FALCON COMMERCE CENTER

**NATIVE SUN CONSTRUCTION**  
 PUD PLAN  
 PROPOSED DRAINAGE MAP

SHEET NO.:  
 PROPOSED DRAINAGE MAP

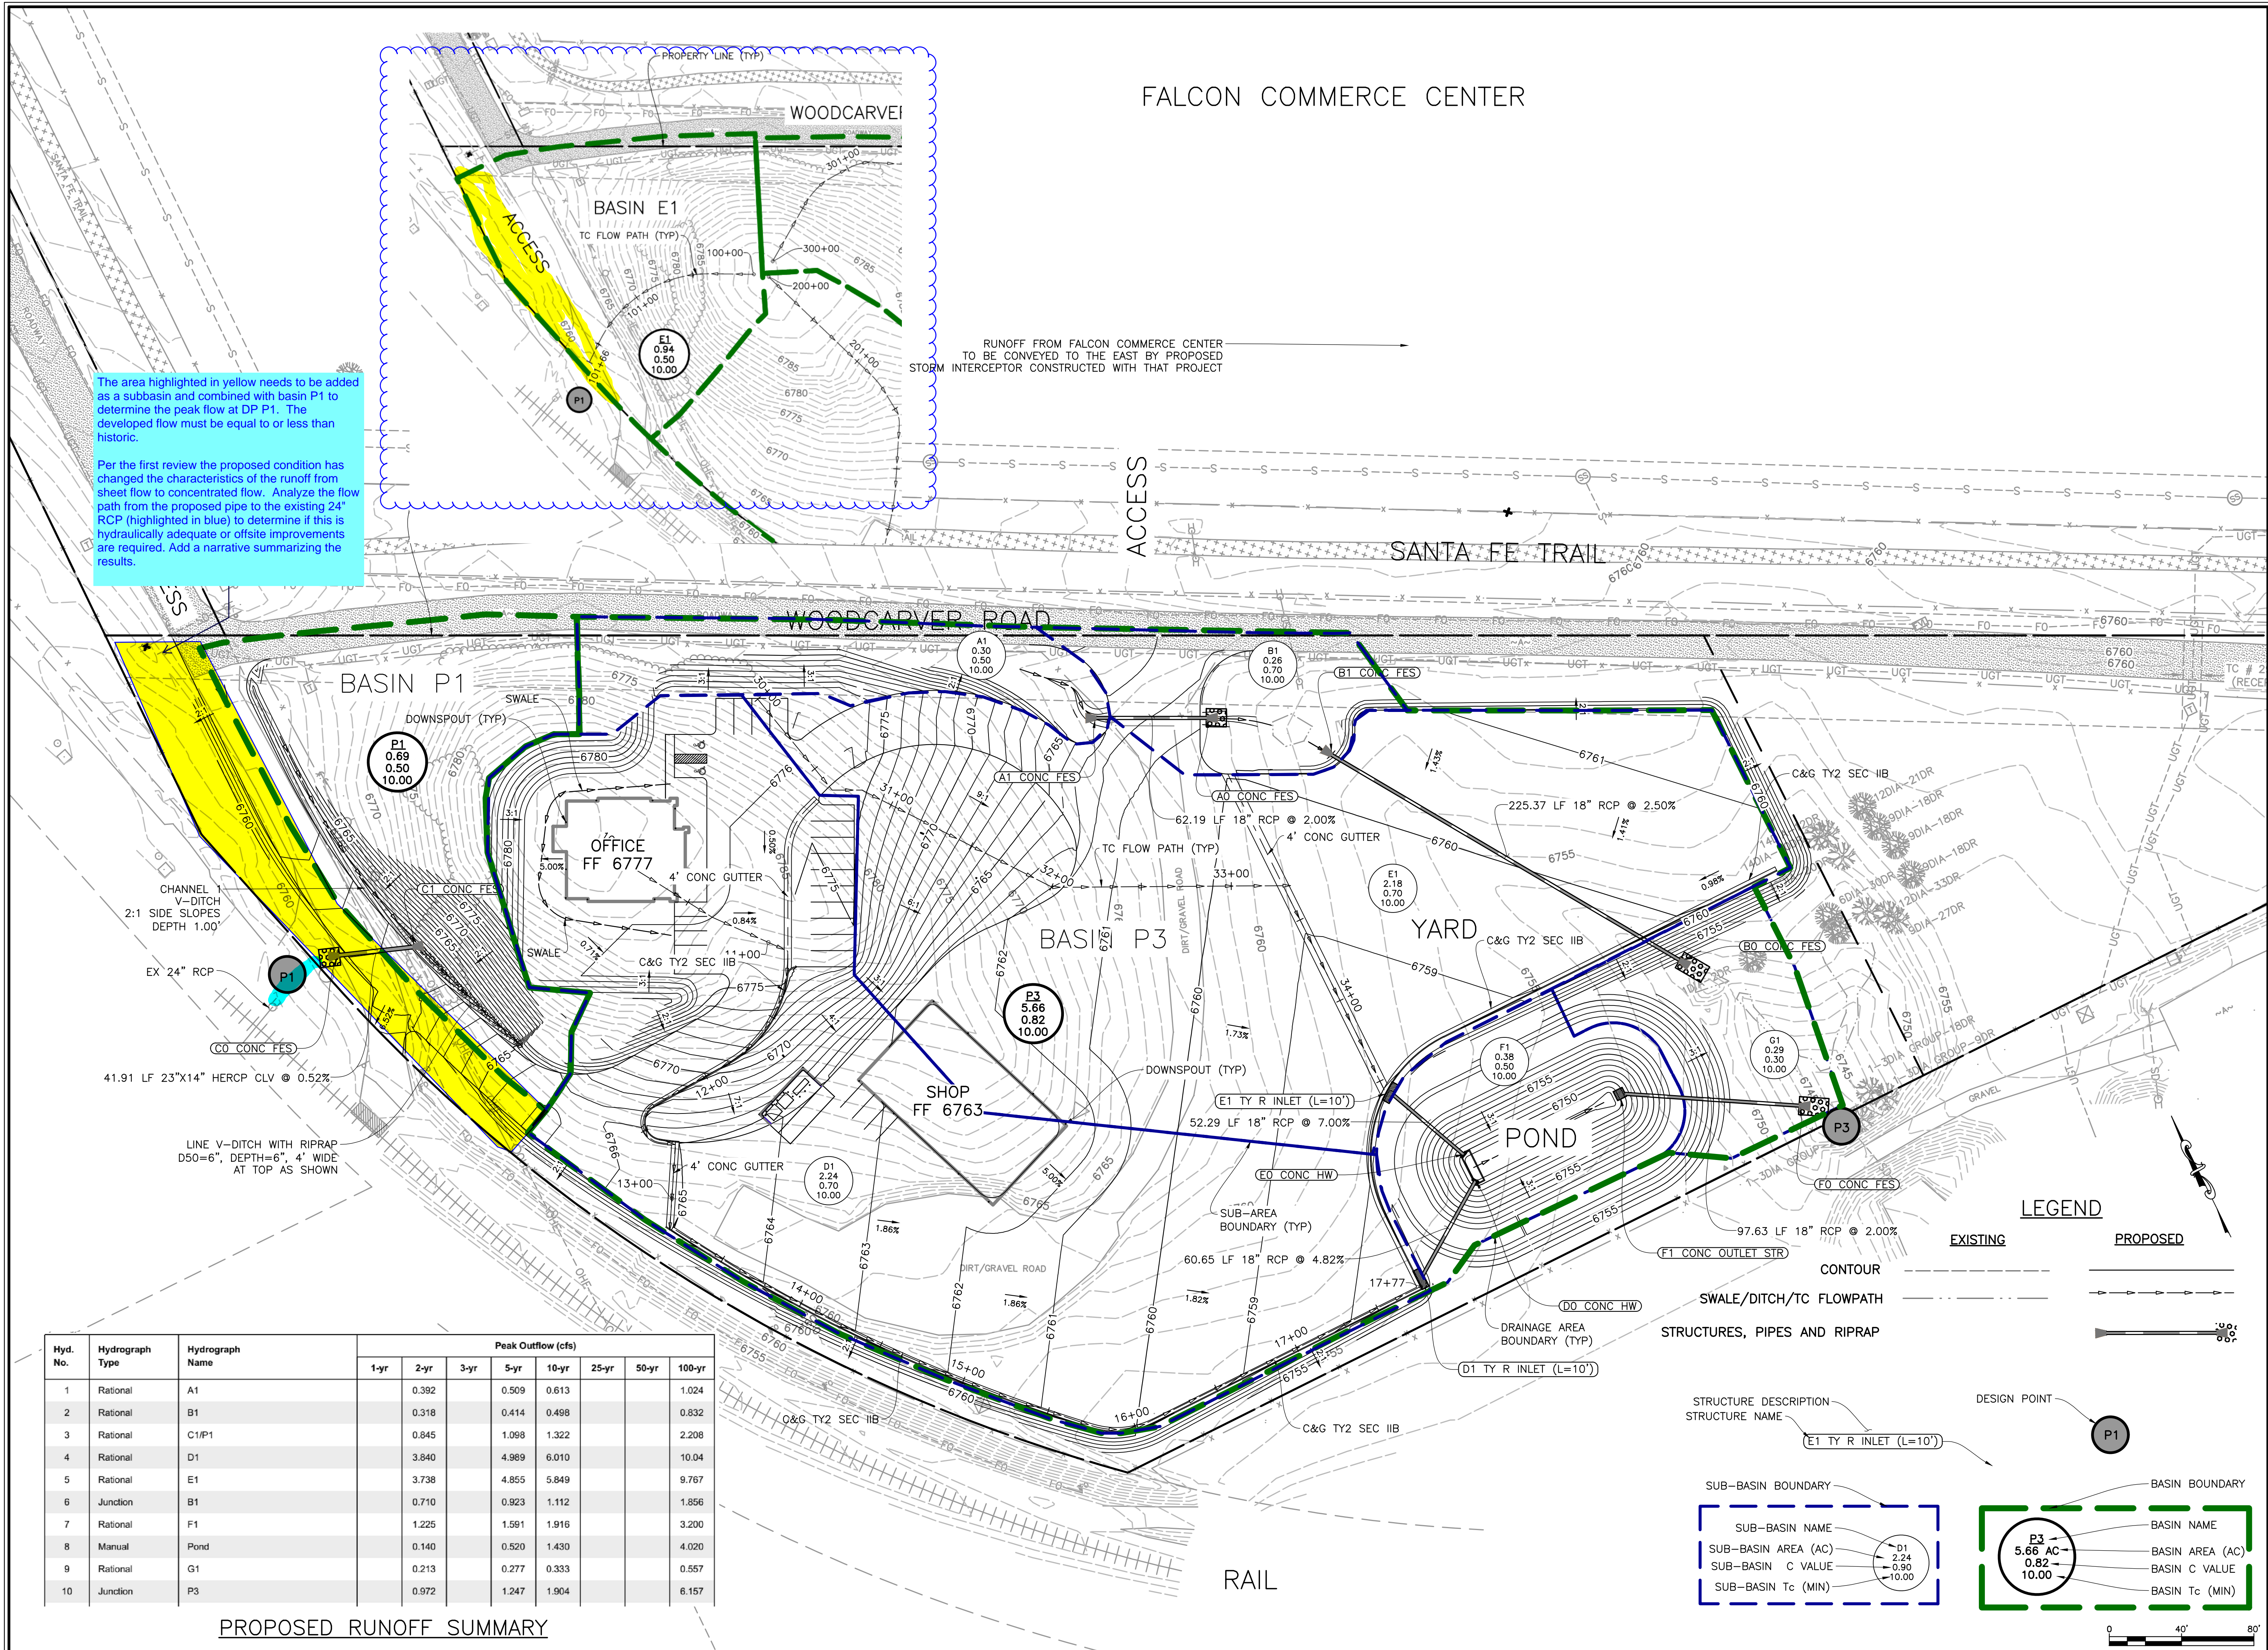
The area highlighted in yellow needs to be added as a subbasin and combined with basin P1 to determine the peak flow at DP P1. The developed flow must be equal to or less than historic.

Per the first review the proposed condition has changed the characteristics of the runoff from sheet flow to concentrated flow. Analyze the flow path from the proposed pipe to the existing 24" RCP (highlighted in blue) to determine if this is hydraulically adequate or offsite improvements are required. Add a narrative summarizing the results.
